PIC18F87J10 Family Rev. A2 Silicon Errata

The PIC18F87J10 family parts you have received conform functionally to the Device Data Sheet (DS39663C), except for the anomalies described below. Any Data Sheet Clarification issues related to the PIC18F87J10 family will be reported in a separate Data Sheet errata. Please check the Microchip web site for any existing issues.

The following silicon errata apply only to PIC18F87J10 family devices with these Device/Revision IDs:

FIGURE 1: SCKx PULSE VARIATION USING TIMER2/2

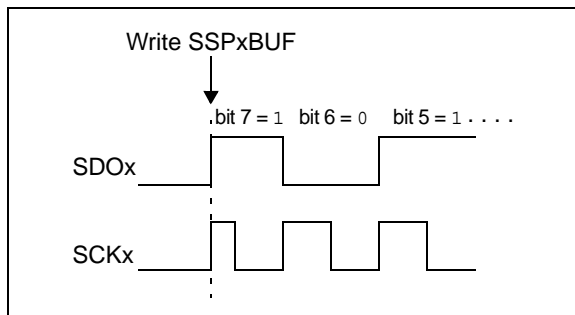
When the SPI is using Timer2/2 as the clock source, a shorter than expected SCKx pulse may occur on the first bit of the transmitted/received data (Figure 1).

To avoid producing the short pulse, turn off Timer2 and clear the TMR2 register, load the SSPxBUF with the data to transmit and then turn Timer2 back on. Refer to Example 2 for sample code.

LOOP BTFSS SSP1STAT, BF ;Data received?
                                ;(Xmit complete?)
    BRA LOOP ;No
    MOVF SSP1BUF, W ;W = SSPBUF
    MOVWF RXDATA ;Save in user RAM
    MOVF TXDATA, W ;W = TXDATA
    BCF T2CON, TMR2ON ;Timer2 off
    CLRF TMR2 ;Clear Timer2
    MOVWF SSP1BUF ;Xmit New data
    BSF T2CON, TMR2ON ;Timer2 on
